100234D
November 1, 2000

Bt8953A/ RS8953B

product bulletin

BCLK Phase Constraints In Repeater Mode; Non-Conformance

100234_001

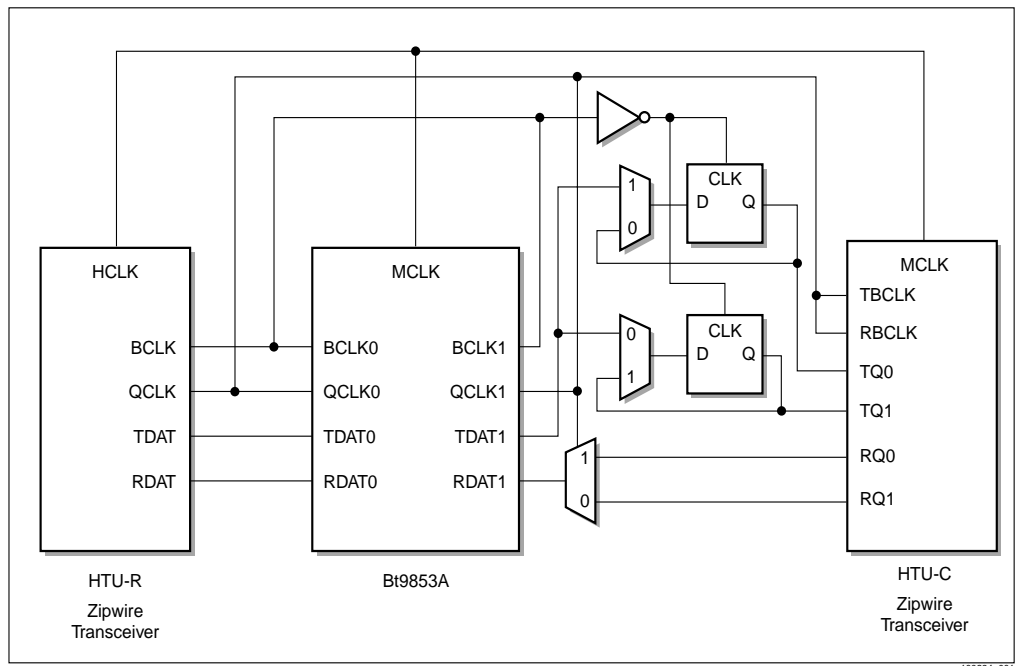
While in repeater mode (REPEAT_EN = 1 for CH1 & CH2), a BCLK1 to BCLK2 phase difference of 180 degrees, +/- 5 nSec, will result in corrupted data transfer. All other phase relationships are acceptable.

In a repeater-mode application, to prevent a phase difference of 180 degrees between BCLK1 and BCLK2, the same clock is feed to both BCLK1 and BCLK2. To use the same clock for both HDSL transceivers, one HDSL transceiver needs to be slaved to the other HDSL transceiver. This is accomplished by setting the HDSL transceiver, which is configured as HTU-C, to "parallel slave mode". Then the parallel signals, from the HDSL transceiver, need to be externally converted to "serial, sign first mode" to interface to the Bt8953A/RS8953B.

To configure the Zipwire transceiver to "parallel slave mode", address 0x06 of the Zipwire transceiver needs to be modified. Also to align the sign and magnitude data correctly, the tbclk_pol and rbclk_pol needs to set properly. The tbclk_pol and rbclk_pol are controlled by address 0x06 of the Zipwire transceiver. TQ[1,0] should be sampled on the falling edge of TBCLK. RQ[1,0] should be sampled on the falling edge of RBCLK.
